13216 SAGE THRASHER LN

RE: Request for an Improvement Permit for Lot 179 at The Sanctuary:
MCHD File #5771B (revision from Feb. 2, 2005 proposed system)

Design Specifications for Lot 179 at The Sanctuary
MCHD File # 5771B

Change Septic System Request

EXHIBIT MAP

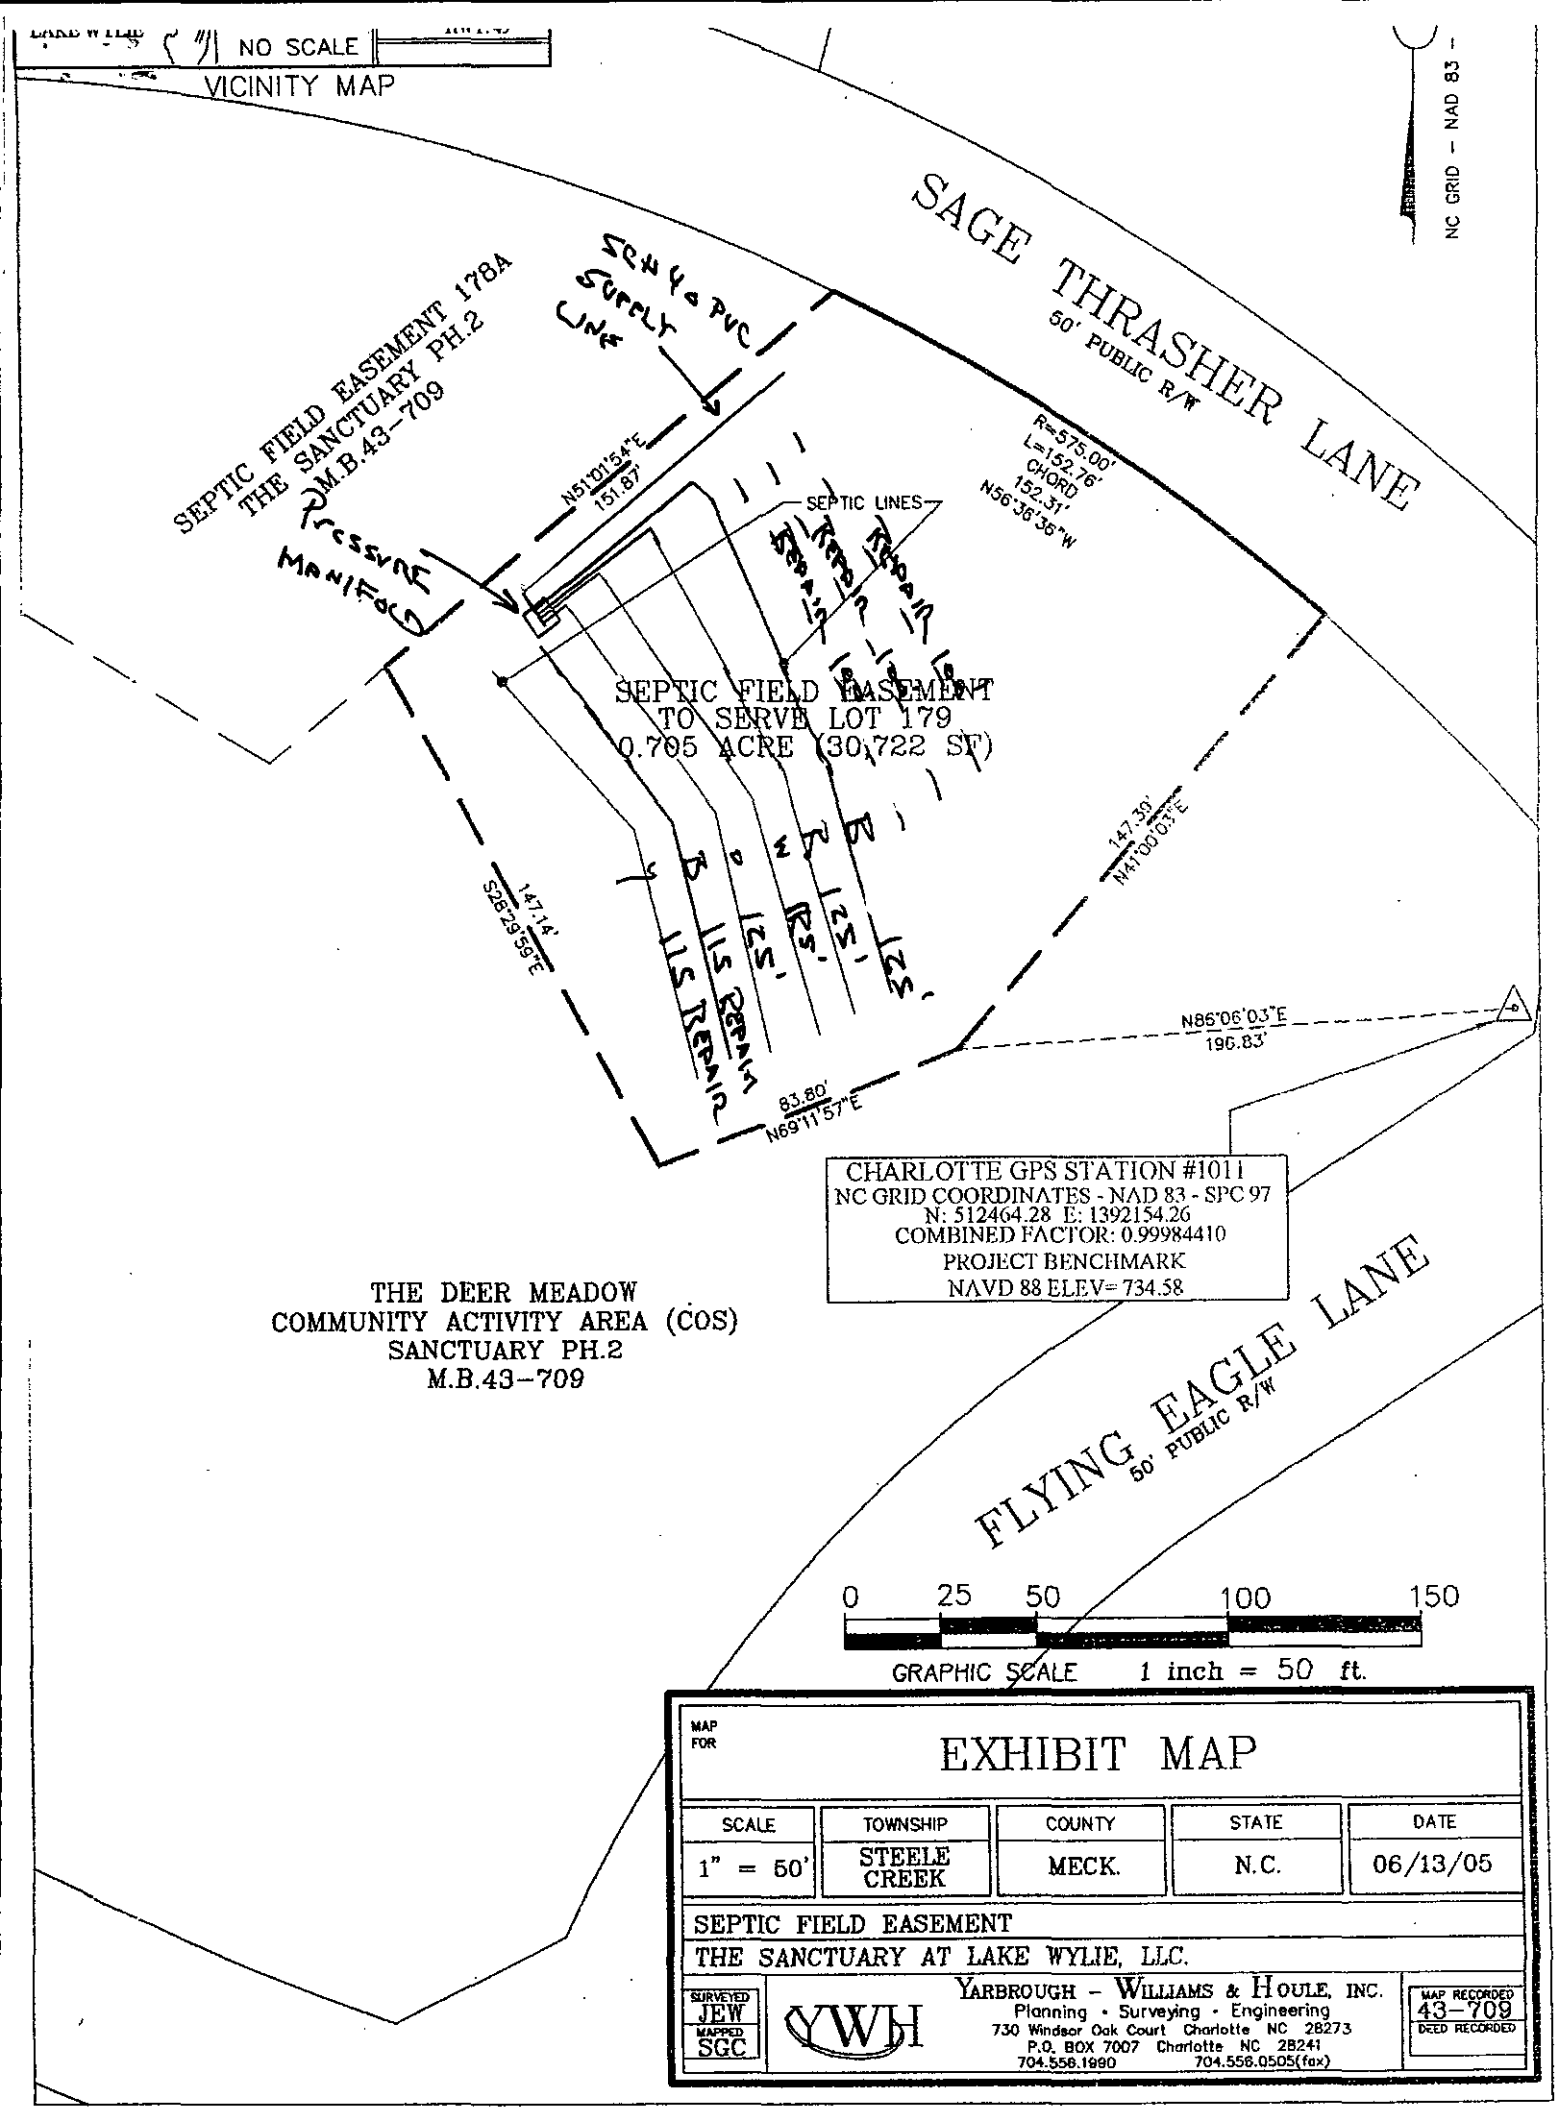
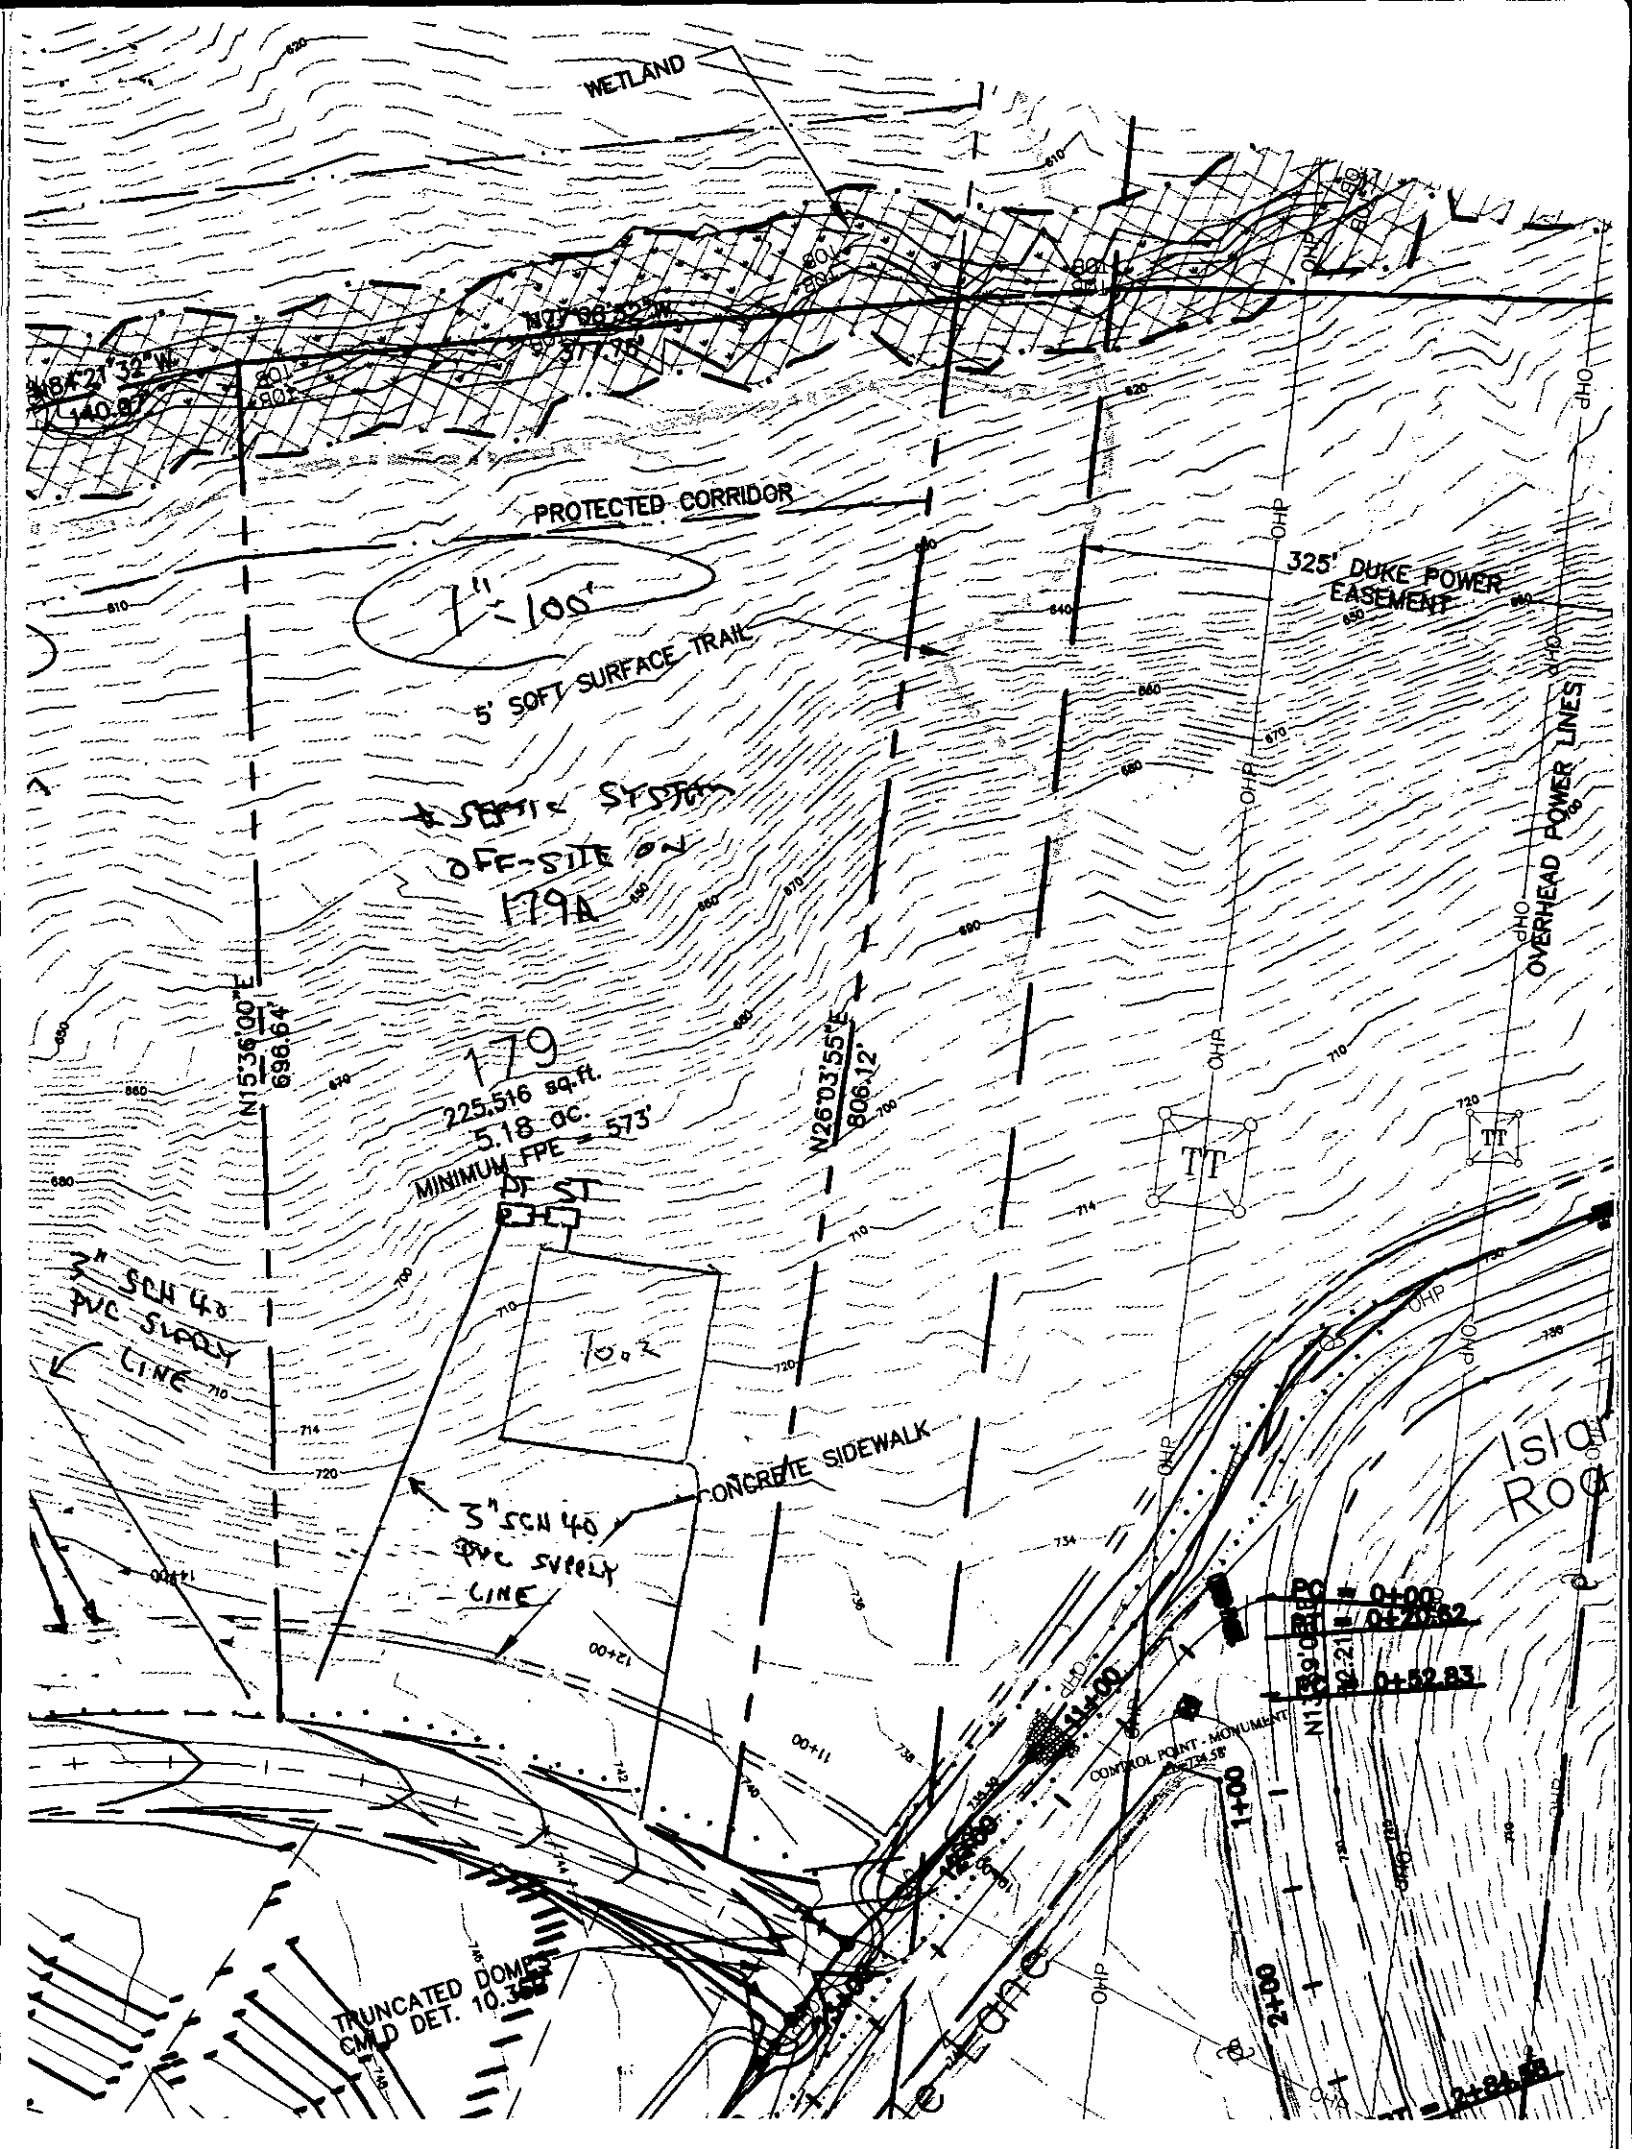
The Sanctuary at Lake Wylie is requesting an Improvement Permit for the above referenced lot. **This lot will utilize an off-site septic area for the septic system drainfield.** Mr. Bill Marlin has evaluated the soils (see attached MCHD soil sheets) and S&ME, Inc. has flagged the system and repair on the septic area. The septic lines have been located by the surveyor and are shown on the attached maps. The attached sketch and specifications are not an Improvement Permit and are intended only to assist the MCHD in permitting the referenced lot at The Sanctuary.

Notes: This lot utilizes an off-site septic area for the drainfield. (revision to Feb. 2, 2005 plan with system on-site)

Daily Design Flow:	600 gpd
Number Bedrooms:	5 bedroom
Basement or Crawl Space:	Basement
Septic Tank Size:	1500 gal
Pump Tank Size:	1500 gal
Primary System Loading Rate:	**0.3 gpd/ft^2**
Primary System:	**25% reduction**
Number and length of laterals:	4 @ 125 ft.
Total ft. of primary system:	500 ft.
Flow Rate through system:	22 gpm – use ½ in. SCH 80 taps with 2 ft. head pressure on pressure manifold (5.5 gpm per tap)
Pump Requirements:	to be calculated by installer when specific house and pump tank locations are available
Dosing Volume:	approx. 270 gal. – 2.2 doses/day at design flow
Depth of effluent pumped per dose:	calculated to specific tank by measure or dealer engineering specifications (1 cubic ft. of water equals 7.48 gal.)
Check Valve:	yes
Siphon break hole:	no
Repair System Loading Rate:	**0.3 gpd/ft^2**
Repair System:	**25% reduction**
Total ft. of repair	530 ft.

Design Specifications for Lot 179 at

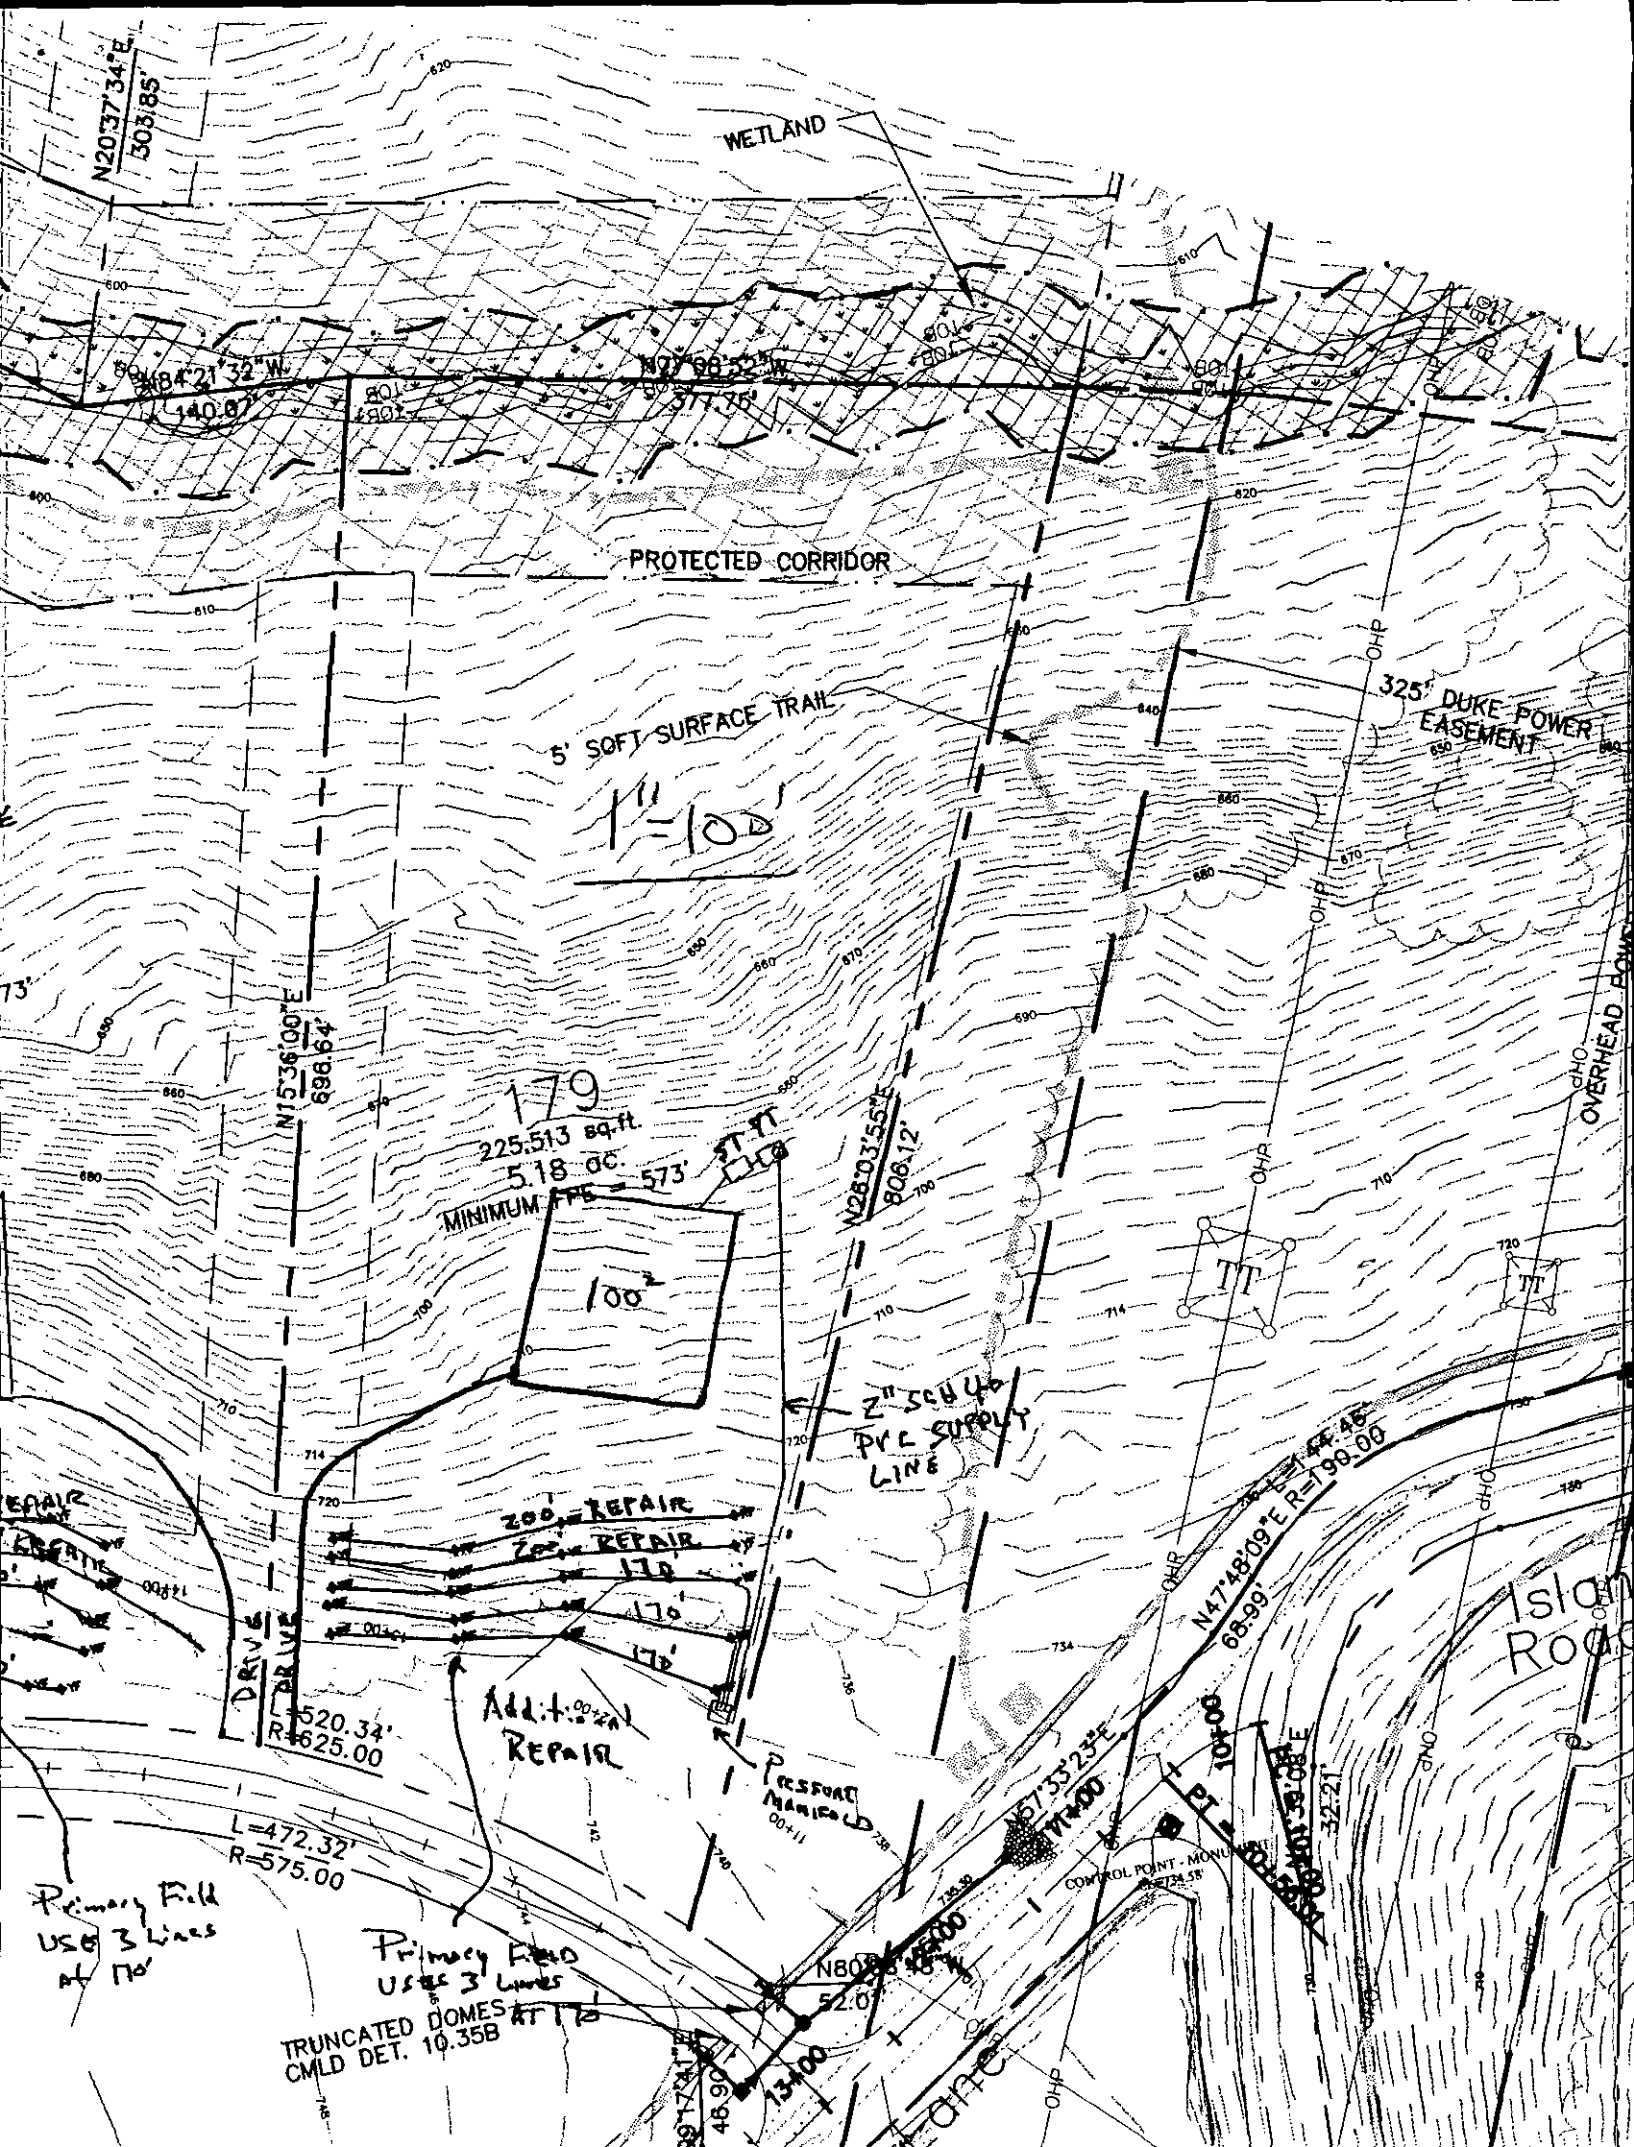
Crescent Resources is requesting an Improvement Permit for lot **179** at The Sanctuary Subdivision for a **5** bedroom, basement home. Mr. Bill Marlin of the MCHD evaluated the soils on 12-09-04 and determined the septic area is PS at an 0.3 gpd/ft^2 LTAR. Toney C. Jacobs and Associates, Inc. has flagged a 25% reduction septic system and PPBPS repair on the lot, as shown on the attached sketch.

System Type:	primary: repair:	pressure manifold , 25% reduction LP PPBPS
Daily design flow:		600 gpd
Septic tank size:		1500 gal. (2 compartments)
Pumping tank size:		1500 gal.
Effluent loading rate:		0.3 gpd/ft^2 for primary and repair
Number and length of laterals:		3 @ 170 ft. 25% reduction
Flow rate through the system:		16.5 gpm –use ½ in. SCH 80 taps with 2 ft. head pressure on pressure manifold (5.5 gpm per tap)
Pump requirements:		to be calculated by installer or owners agent when specific house and pump tank location are available
Dosing volume:		approx. 270 gal. – 2.2 doses/day at design flow
Depth of water pumped per dose:		calculated to specific tank by measure or dealer engineering specifications (1 cubic ft. of water equals 7.48 gal.)
Check valve:		YES
Siphon break hole:		No
